ADDENDUM NO. 3

COMMUNITY PARK ELEMENTARY SCHOOL

Issued: January 30, 2026

FVHD PROJECT NO. 5516C

3 SECOND FLOOR TEMPORARY EGRESS PLAN
3/16" = 1'-0"

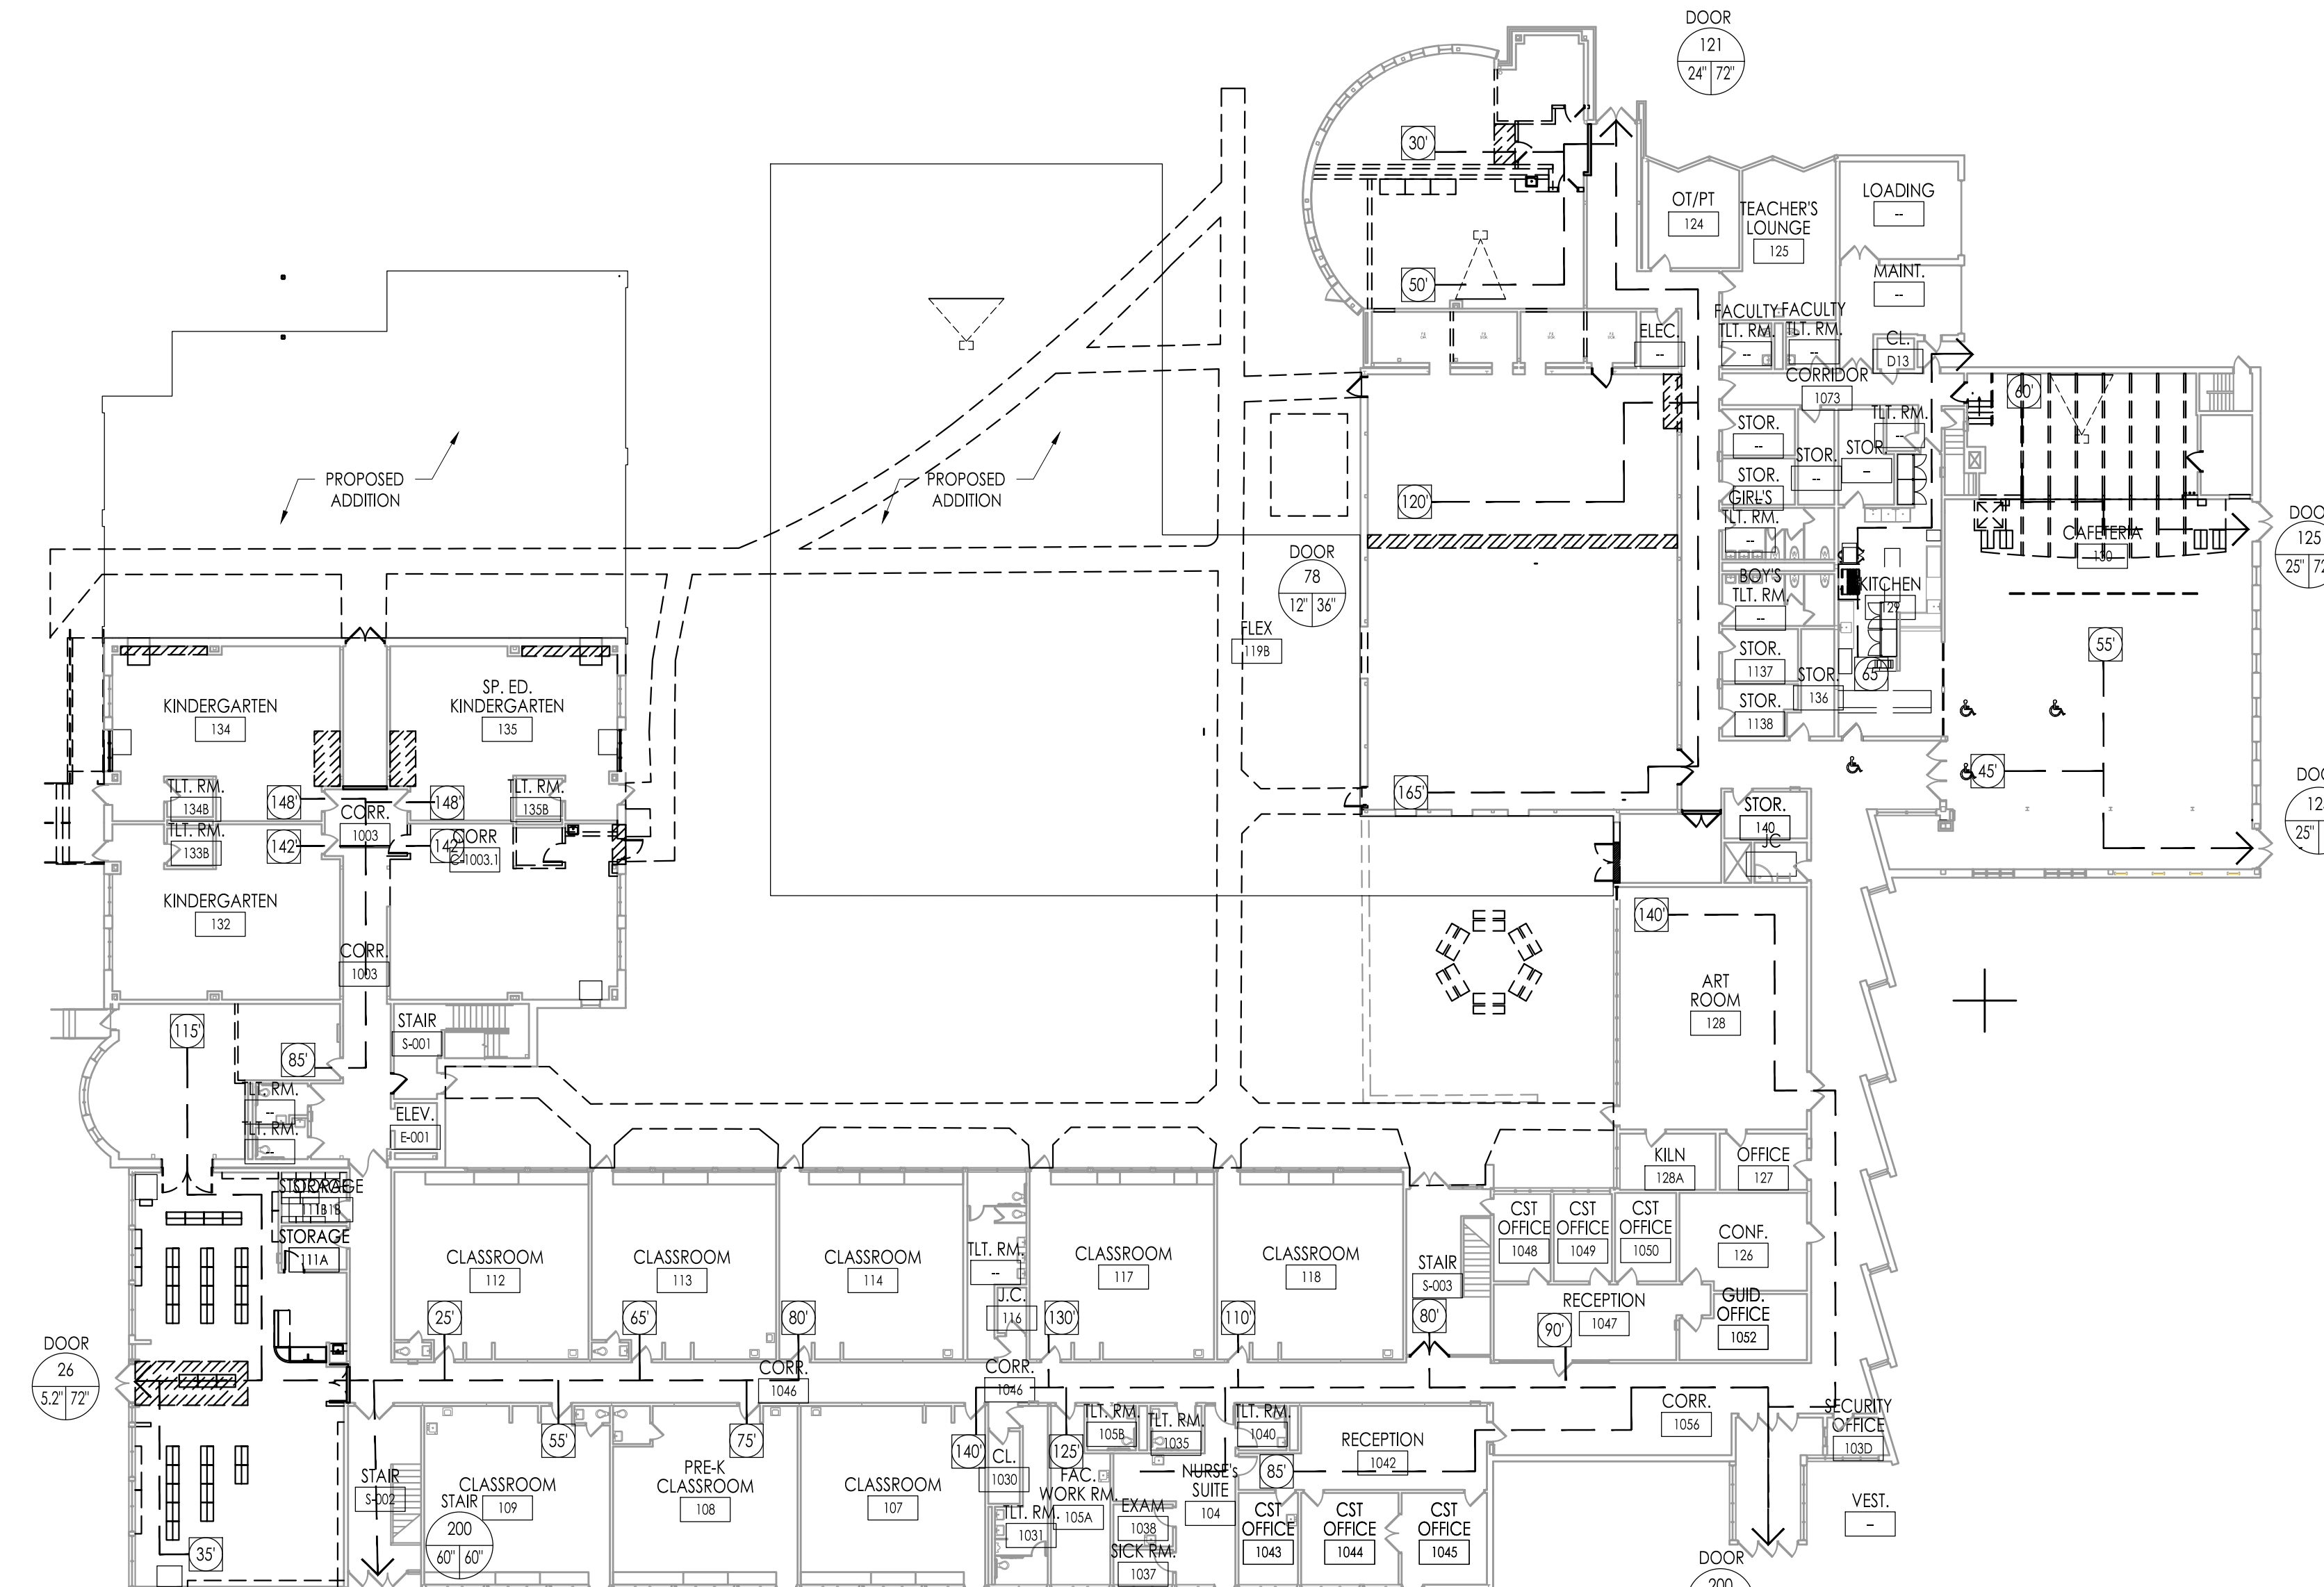
- CHANGE DOOR TO SWING OUT OF STAIR AND INTO HALLWAY. HINGE TO ALLOW FOR 180° SWING FOR COMPLIANCE WITH 2021 IBC NJ EDITION 1005.7.1.
- TEMPORARY CONSTRUCTION ENTRANCE. CONTRACTOR TO COORDINATE WITH OWNER AND CONSTRUCTION MANAGER FOR PERSONAL ACCESS.
